Commercial Lighting Solutions, Webtool Peer Review Report

Carol Jones, Associate IALD, IESNA, LC, Pacific Northwest National
Laboratory

February 2009

Sign-in

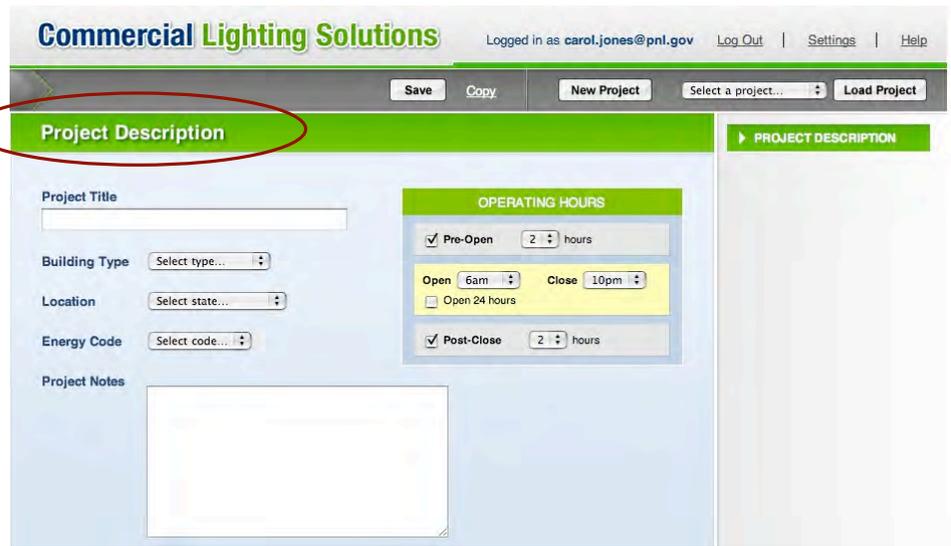
G Subisak	GS1	Manufacturer		Sign-in	I went to sign-in without having an account, make the new user feature more obvious.	Guidance	Ease of use/flow	71	4	2	2.4	4	5	5	4.7	37.8	27.5
S Williams	SW1	Retailer		Sign in	Sign in process should have two green boxes, to make it more obvious that you need to set up an account if you don't have one yet. "Sign-In" or "Create Account"	Guidance	Ease of use/flow	71	4	2	2.4	4	5	5	4.7	37.8	27.5
K Abernathy	KA1	Lighting Designer			It wasn't obvious enough to me that I needed to create an account. Only figured it out after I couldn't sign in. Add a "new user" or "register."	Guidance	Ease of use/flow	71	4	2	2.4	4	5	5	4.7	37.8	27.5
S McDonald	SM10	Generalist		Discount Big Box Design Vignettes	OK, cool, but, takes some time to absorb what this is. Yes, it is very clean, almost too clean. It would give me a better feel if you had a grayed out parking lot and green space so I could say, "Oh yeah, this is a building. When I selected a General Sales Lighting Vignette, and checked the box, I could see that there was a place for floorspace if I scrolled down...but it is probably NOT obvious to everyone. The additional page space appears, but is not obvious...it would be better to automatically expand the box if such a thing is possible.	Flow	Ease of use/flow	44	5	5	5	2	3	4	3	38.0	47.0

C DiLouie	CD7	Manufacturer		Sign-in	Add another dark green band toward bottom of box, with caps that say REGISTER, while putting SIGN IN in black instead of white to stand out more	Style Changes	Ease of use/flow	71	4	4	4	4	5	5	4.7	44.2	41.1
T Betz	TB5	?		Vignettes	The visual indicators on the screen (the "percent exceeding code", the navigation buttons on the right, etc) should be labeled as such so that the user will immediately understand their functionality and not have to play with the program and accidentally figure out their purpose. Use labels such as "Percent Design Exceeds Code" and "Navigation buttons".	Guidance	Ease of use/flow	41	2	5	4.4	4	5	5	4.7	45.8	44.5
T Betz	TB3	?		General	The information provided by the "percent scale" at the bottom of the screen is not intuitive. I assume it means the percentage by which the design is beating the baseline, but it is not specifically noted as such.	Guidance	Ease of use/flow	41	3	5	4.6	4	5	5	4.7	46.6	46.2

**Specialty
Market
Key Plan**

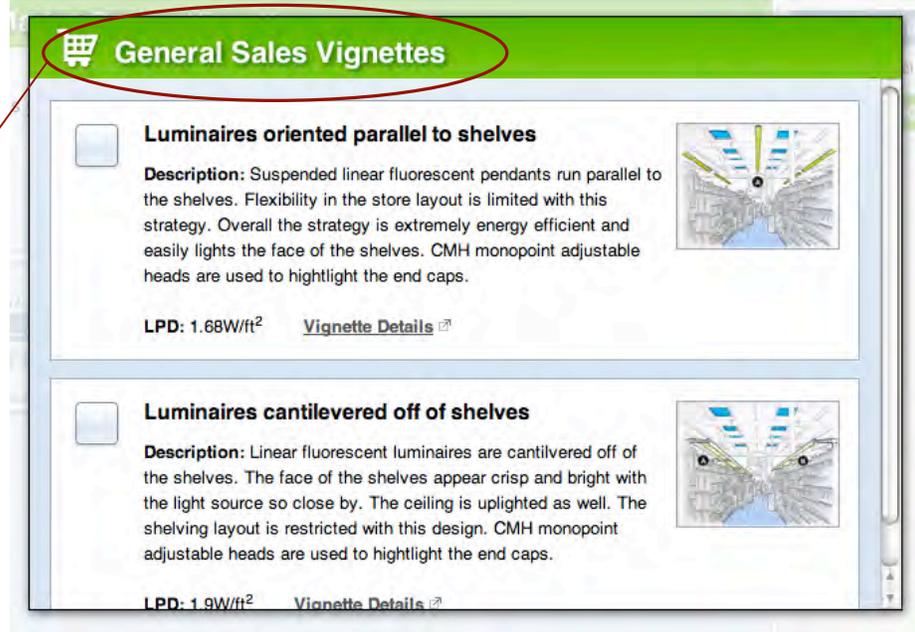
B Hamilton	BH18	Core Team		Specialty Market Key Plan	The instructions should be aligned to the left of the screen, so they are not covered up when the Vignette dialogue box appears.	Flow	Ease of use/flow	LT	1	3	2.6	4	4	3	3.7	32.6	27.7
V Barr	VB3	State			There should be an option to remove a project from your list and one project was listed three times after saving it once.	Additions	Ease of use/flow	TBD	3	4	3.8	3	3	3	3	33.2	36.8
L Coyan	LC4	?			State selection should bring up what the state has adopted for an energy code with the caveat that the local jurisdiction might be different.	Code Look-up	Ease of use/flow	46		5	4	3	3	3	3	34.0	38.5
C DiLouie	CD19	Manufacturer			To me there is no sense of connection of what I'm supposed to do next in some places. Most times, this is intuitive, but in some cases, it's not. For example, I am given default controls choices for my chosen vignette but then I am able to pick new controls, but 1) the controls didn't match up between the default choices and my new choices when I clicked the Controls tab, and 2) it's not clear to me that I really should pick controls. Again, I believe there should be a sense of process, or handoffs, from 1) set up your building to 2) choose your lighting to 3) choose your control strategies to 4) download your documentation. The user should be shepherded into these. As it is, they are forced to do #1 and #2 and then they're left to their own devices to do #3 and #4 optionally. It should all be tied together into a clear process.	Flow	Ease of use/flow	74	1	3	2.6	5	4	3	4	34.4	28.1

S Stutzman	SS11	Retailer	Specialty Market	Key Plan	Directions must be more explicit. E.g., "Click on a store type to see a vignette." Not immediately apparent about what to do when you get to the key plan.	Guidance	Ease of use/flow	50	4	5	4.8	5	5	5	5	49.2	48.3
L Davis	LD26	Lighting Designer	Grocery Store	Vignette Summary	Nighttime dimming shows up under Control Strategy but was not selected.	Functionality	Functionality	55	1	2	1.8	4	4	2	3.4	27.6	20.4
T Coughlin	TC2	Utility		key plan	Button is blinking when I hit "next."	Functionality	Functionality	TBD	1	3	2.6	3	4	4	3.7	32.6	27.7
T Coughlin	TC3	Utility		vignette lists	Tabs are flashing when I run the mouse over the links.	Functionality	Functionality	TBD	1	3	2.6	3	4	4	3.7	32.6	27.7
T Coughlin	TC4	Utility		vignette lists	Going in and out of the vignettes-- sometimes the link isn't working.	Functionality	Functionality	TBD	2	3	2.8	3	4	4	3.7	33.4	29.4
